Agenda Item 3 1051 Cedar Lane Five-Car Garage Addition, Exterior Alterations & Hardscape

Consideration of a request for approval of an attached five-car garage addition, exterior alterations, and new hardscape.

Staff Contact: Jen Baehr, Planner

9 19 **A-9 ENLARGED PROPOSED ELEVATIONS**

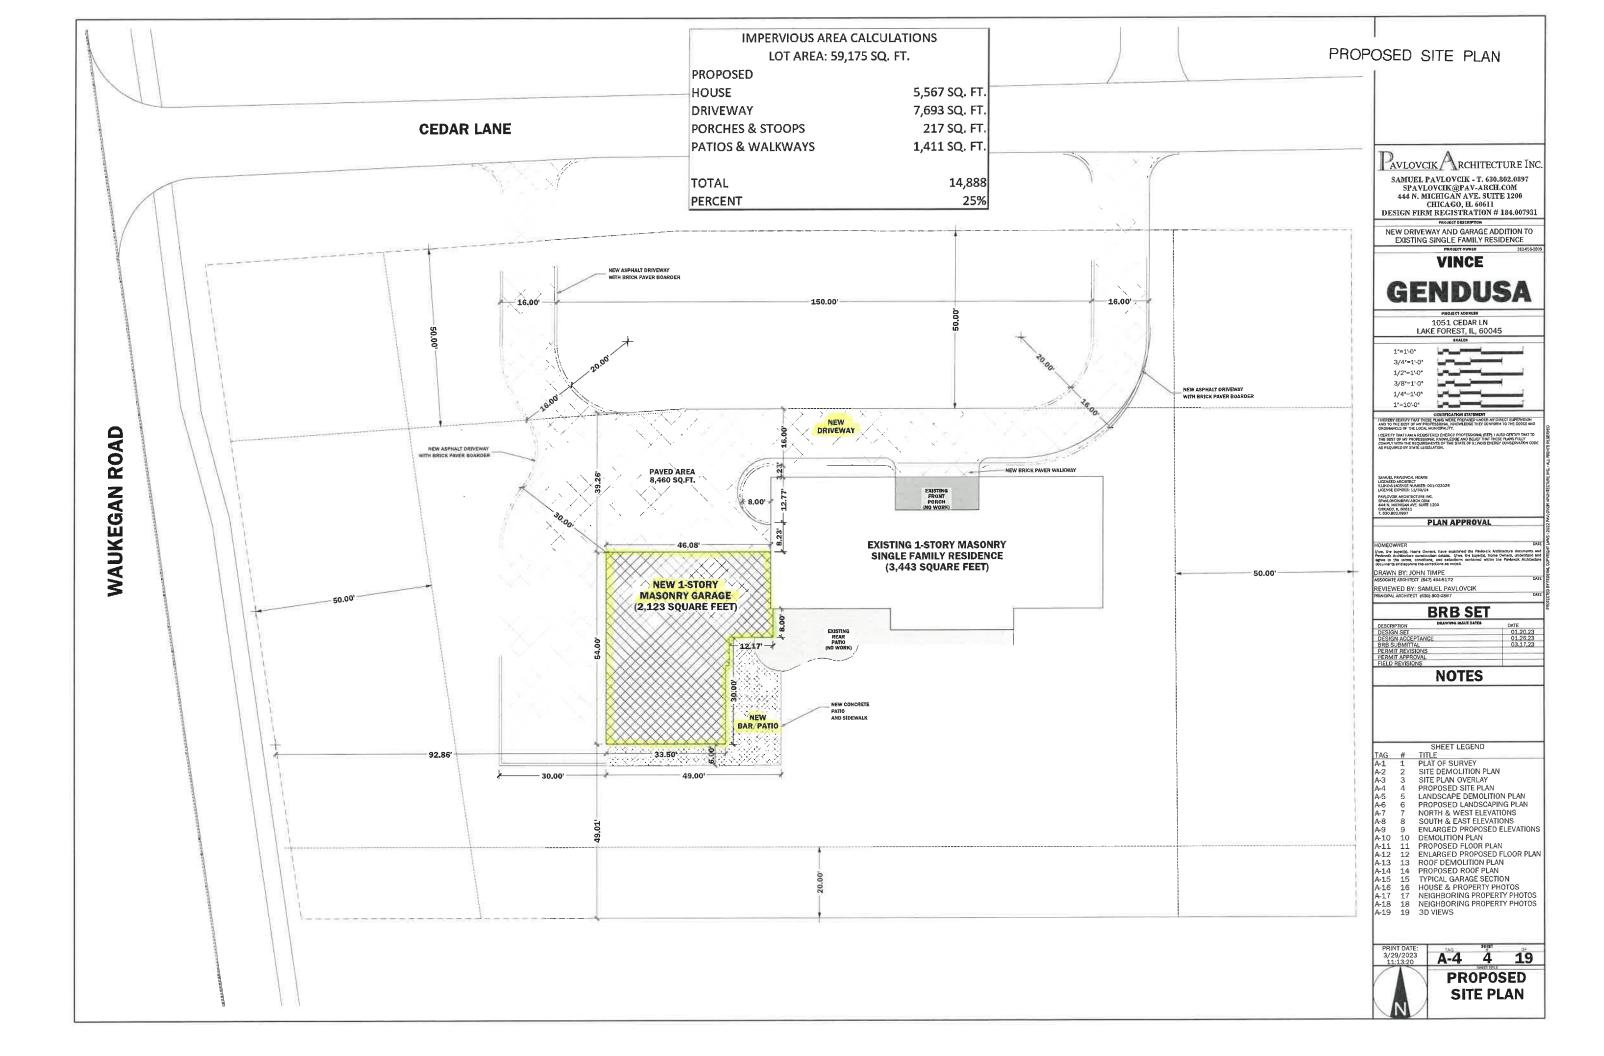
The proposed garage addition presents a single-story massing and simple gable roof form to match the existing home. As noted above, three garage doors are proposed to face Cedar Lane and two garage doors will face Waukegan Road. As stated in the City's Residential Design Guidelines, attached garages should be side-loading to avoid facing the street. Staff encouraged the petitioner to consider reducing the number of garage doors that face Cedar Lane to maintain a residential character along the streetscape.

The design of the addition is very simple and appears to present a commercial appearance with its lack of articulation and the box-like shape. The west elevation which faces Waukegan Road, is comprised of two single garage doors and a large area of solid brick.

- > Staff recommends further articulation of the addition and the incorporation of projecting or recessed elements to add depth to the addition to avoid a box-like and commercial appearance.
- > Staff recommends incorporating openings on the west elevation to break up the large expanse of solid wall.

- > Clarification on the type of window muntins proposed is requested.
- > Staff recommends a different style garage door to avoid a commercial like appearance.
- > Staff recommends a clay chimney pot, consistent with the City's Residential Design Guidelines.
- Clarification on the material proposed for the porch columns is requested.

- 6. Incorporate openings on the west elevation to break up the solid wall.
- 7. Incorporate a clay chimney pot on the new chimney.
- 8. Conduct further study of the style of the garage doors.
- 9. Provide an updated tree removal plan that identifies all trees proposed for removal with details on species, size, and condition.
- 10. Provide a detailed landscape plan that screens views of the addition and rear porch from all directions to the extent possible.

A-14 14 19 **PROPOSED ROOF PLAN**

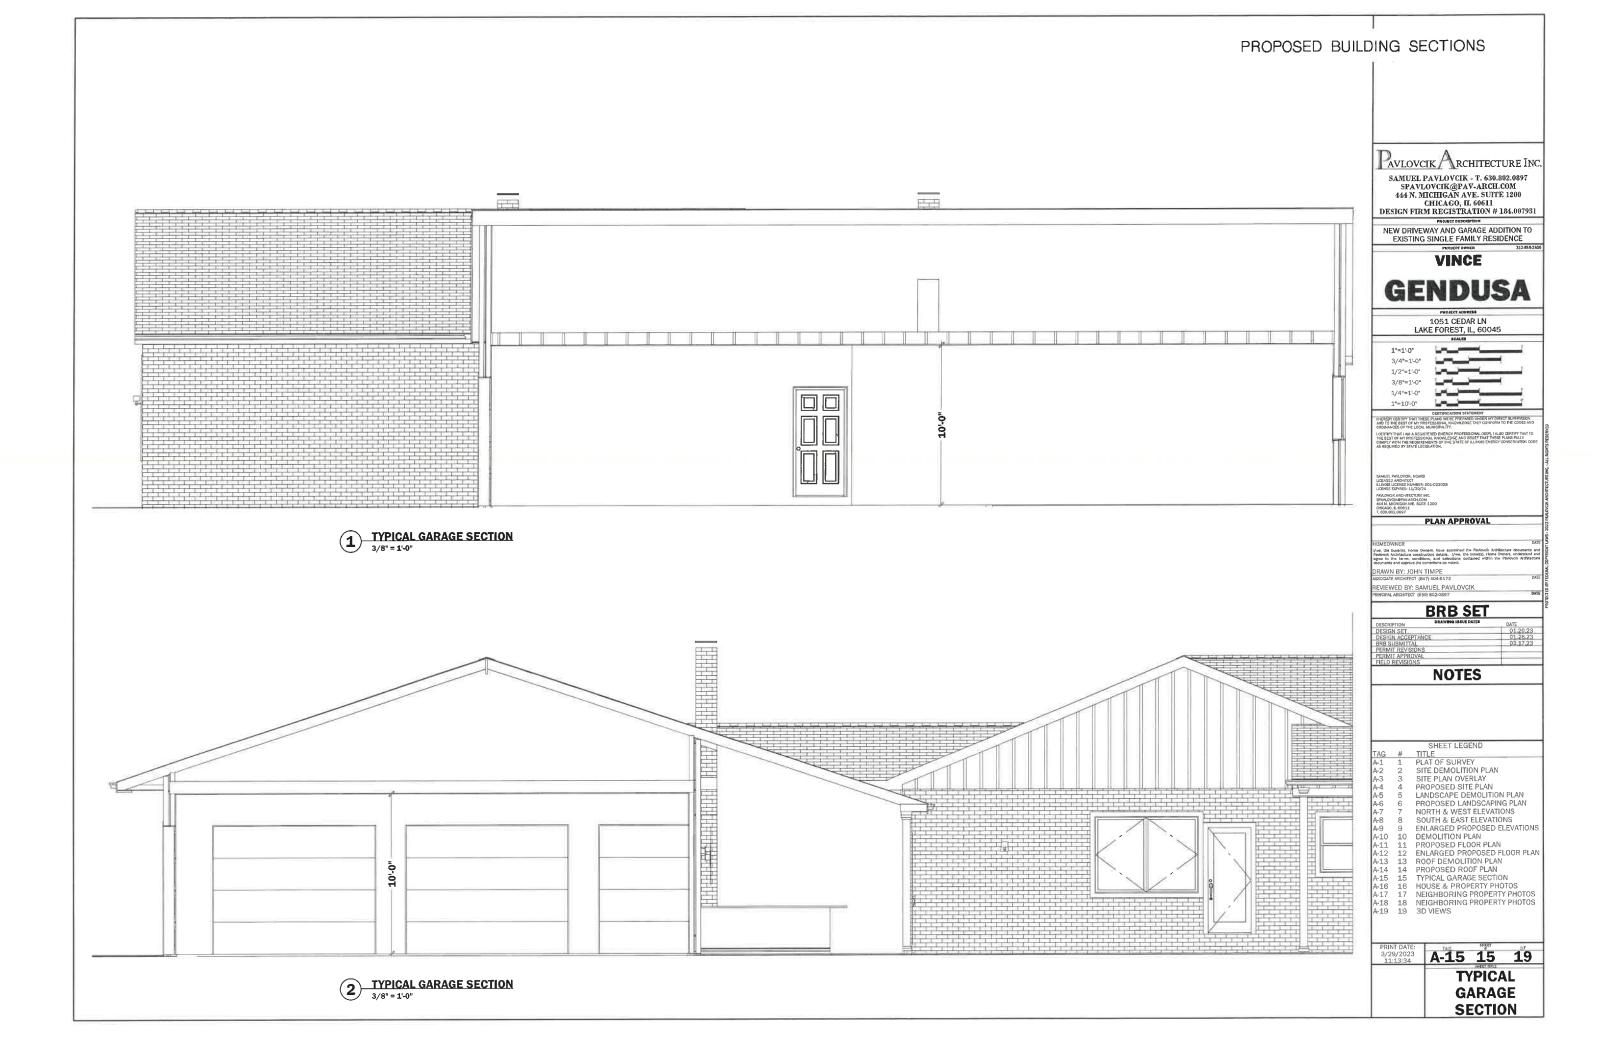
It is unusual for an addition, particularly a garage addition, to exceed the height of the existing home and be more than half the size of the house. Garages are typically intended to be secondary to the main residence, and in this case, the size and height of the garage appears to compete with the residence. There are some instances in Lake Forest where below grade garages have been constructed for instance by residents who are car collectors, however, those do not add to the massing or impact the visual character of a neighborhood.

The petitioner provided an alternate design and it is included in the Board's packet. The alternate design presents a more complex and awkward roof form. Although the alternate design attempts to break up the front façade of the garage addition, it does not appear to address the concerns about the scale of the garage in relation to the existing home.
